## ADDENDUM NO. 2

DATE: October 11, 2013

Contract 13-C-00019; Howard F. Curren AWTP Screen and Grit Building No. 1 Bar Screen Replacement

HFCAWTP SCREEN AND GRIT  
 BLDG. NO. 1 BAR SCREEN REPLACEMENT  
 PROPOSED SECTION C/7  
 W.O. 5907  
 SHEET 8  
 OF 11

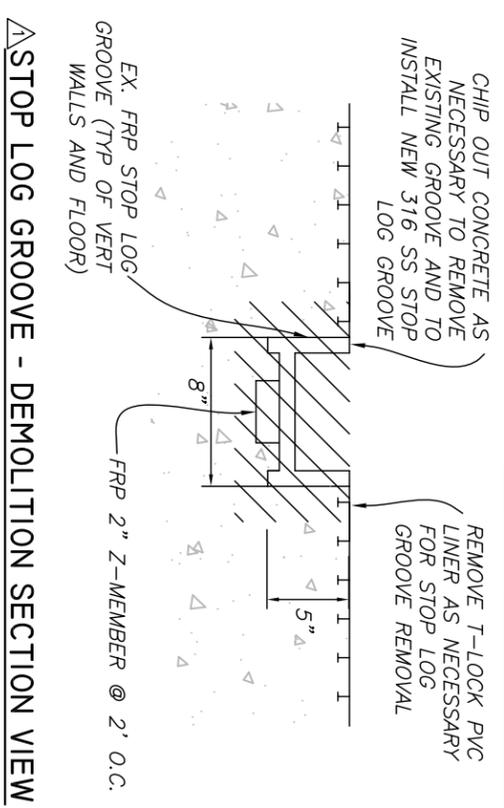
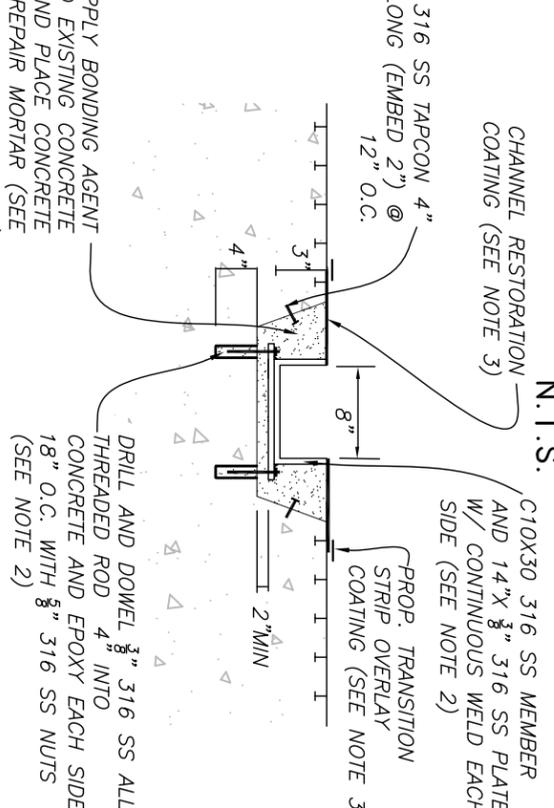
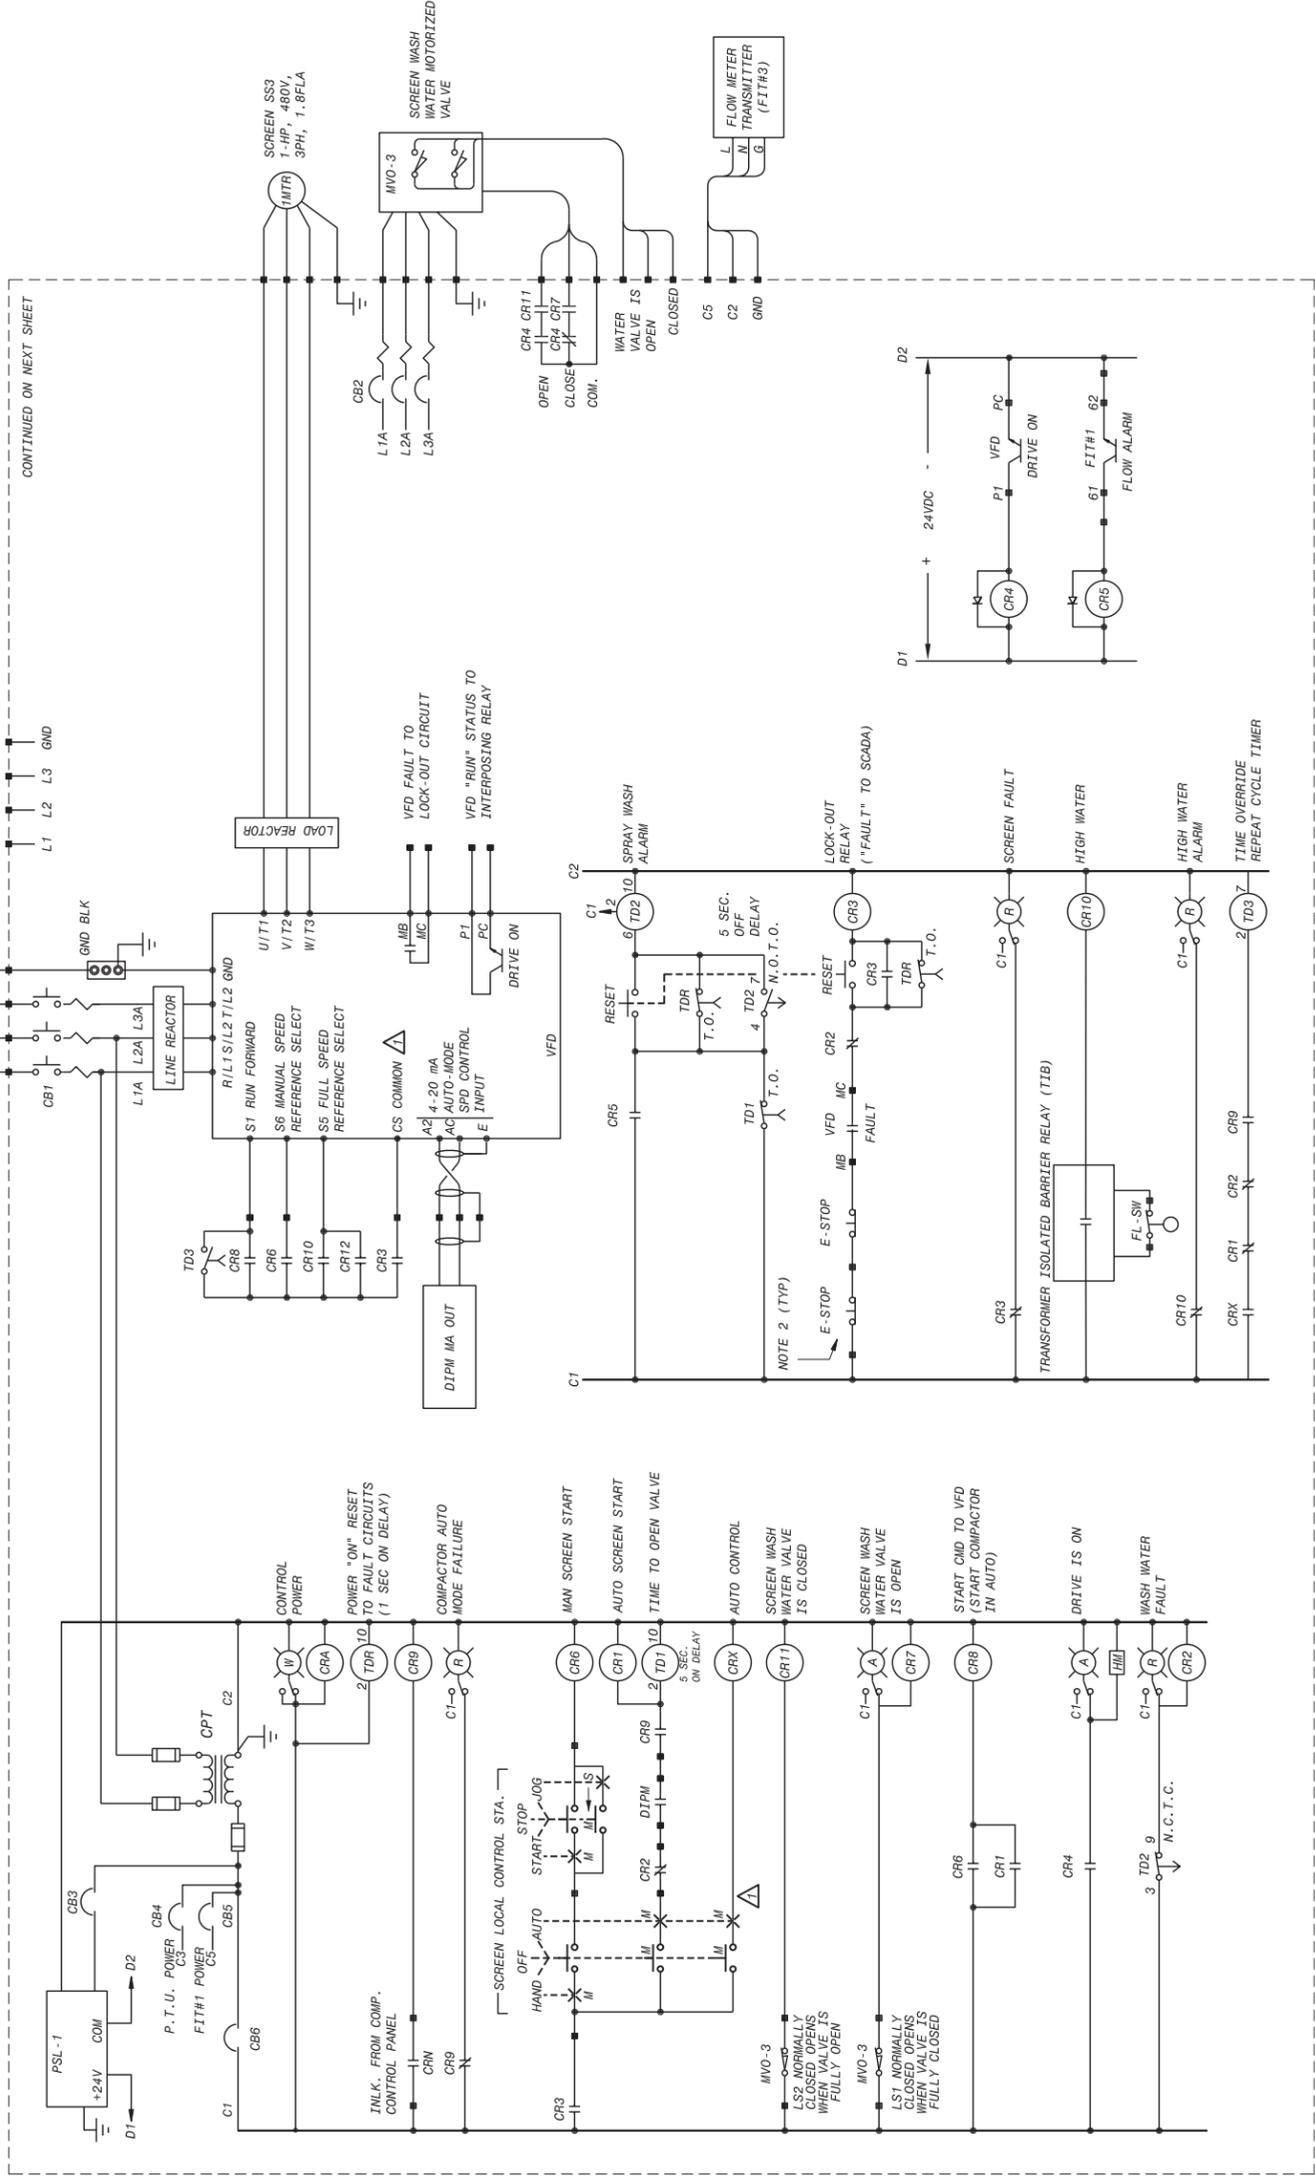
- Item 5: Replace Technical Specifications with the attached Technical Specifications.
- Item 6: Replace Plan Sheets Nos. 7, 8, 11 and E-12 with the attached Plan Sheets 7, 8, 11 and E-12.
- Item 7: Attached for reference is the pre-bid meeting sign-in sheet.

- NOTES:
1. THERE ARE A TOTAL OF 6 STOP LOG GROOVES TO BE RESTORED. THE RESTORATION INCLUDES THE WALLS AND FLOOR
  2. COST FOR THE STOP LOG GROOVE RESTORATION INCLUDING REPAIR MORTAR, SHALL BE INCLUDED IN THE PROJECT'S LUMP SUM BID ITEM
  3. PAYMENT FOR CHANNEL RESTORATION AND STRIP OVERLAY COATINGS WILL BE BASED ON APPROPRIATE UNIT COST
  4. THE FLOOR IS NOT T-LOCK LINED AND DO NOT REQUIRE COATINGS
